# UNITED STATES PATENT AND TRADEMARK OFFICE

10/661,494

<b>Office Action Summary</b>	<b>Application No.</b>		<b>Applicant(s)</b>	
	10/661,494		RHODES, HOWARD E.	
	<b>Examiner</b>		<b>Art Unit</b>	
	PAUL BERARDESCA		2622

## **DETAILED ACTION**

FIG. 7

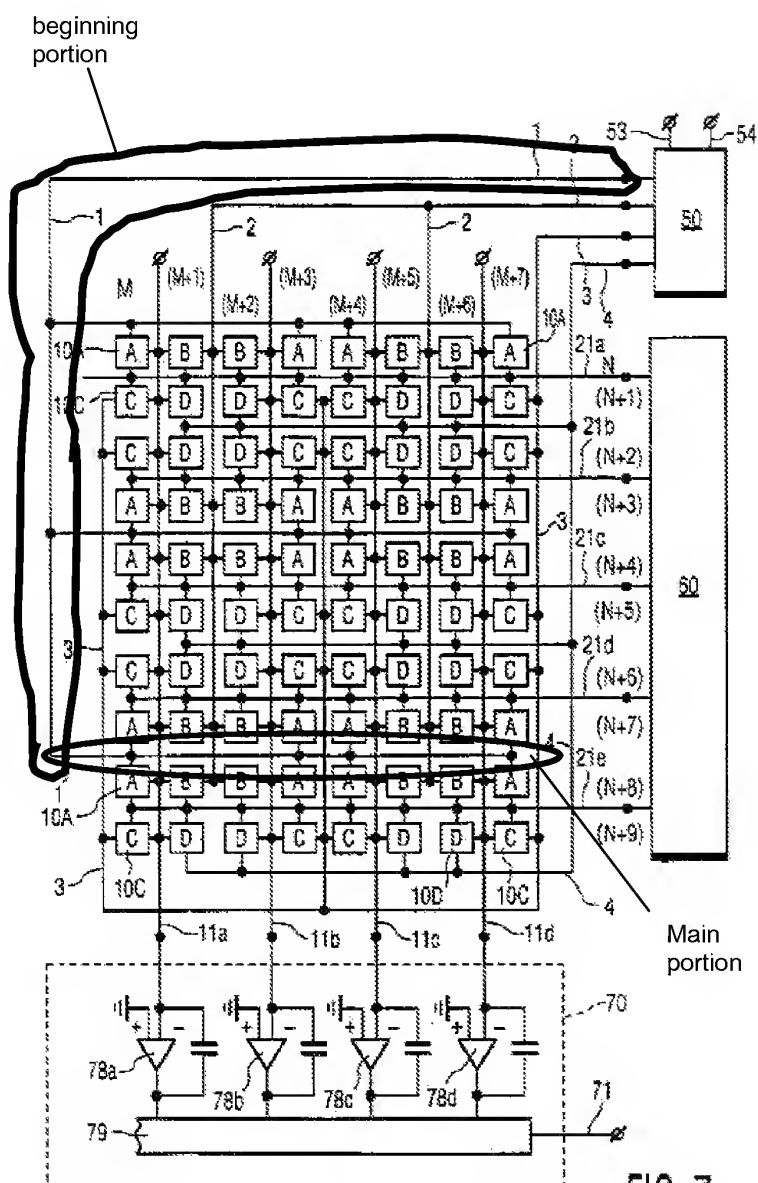
Applicant's arguments, (Bird does not indicate the reset line “extends approximately linearly across the pixel array”) with respect to claims 80 and 84 filed 1/28/2008 have been fully considered but they are not persuasive.

As clearly shown in figure 7, an expanded version of figure 1, reference line (1) extends from one end of the array at pixel A to the opposite end of the array at another pixel A in a straight horizontal line. The only possible way that reference line (1) can be interpreted as traveling circuitously is in the beginning portion of the reference line (1) as labeled above, which travels from voltage pulse generator (50) around to the left side of the array to where it begins traveling linearly across the array, wherein in that beginning portion, the reference line (1) is not even traveling **“across”** the array, which leaves the main portion as labeled above as the only section of the reference line (1) that travels across the array, wherein the main section is clearly a straight line. In addition, even if the reference line is thought to be traveling circuitously as a whole, because the main portion is part of the reference line (1) and it is linear across the array, it is enough so that the reference line (1) as a whole is **“approximately”** or **“substantially”** linear as so broadly claimed. Similarly, reference line (2) extends linearly from the top of the array to the bottom of the array and therefore travels **“approximately linearly across the pixel array”**.

Regarding claim 102, Bird discloses a pixel array comprising a row (top row of figure 7) comprising a plurality of first pixels (odd pixels of the row starting with A on the left in figure 7) and a plurality of second pixels (the second A from the left and the last A in the row), which reads on claimed, ***“a pixel array comprising a row comprising a plurality of first pixels and a plurality of second pixels”***, as exhibited in figure 7.

In addition, Bird discloses a respective column line (11) for each pair of first and second pixels of the row, which reads on claimed, ***“a respective column line for each pair of first and second pixels of the row”***, as exhibited in figure 7. Specifically,

because there are only two **"second pixels"**, there are only two **"pair[s] of first and second pixels of the row"**, wherein each one ([the second A from the left and the second B from the left] and [the first A from the right and the first B from the right] as in figure 7) has its own column line (11).

Regarding claim 103, Bird discloses everything claimed as applied above (see claim 102), in addition, Bird discloses the plurality of first pixels are the odd pixels of the row starting from A on the left, which reads on claimed, **"wherein the plurality of first pixels are every other pixel in the row"**, as exhibited in figure 7.

Regarding claim 104, Bird discloses everything claimed as applied above (see claim 102), in addition, Bird discloses wherein each pair of first and second pixels of the row are arranged with the first and second pixels positioned adjacent each other along the column line (11), which reads on claimed, **"wherein each pair of first and second**

**pixels of the row are arranged with the first and second pixels positioned adjacent each other along the column line”,** as exhibited in figure 7.
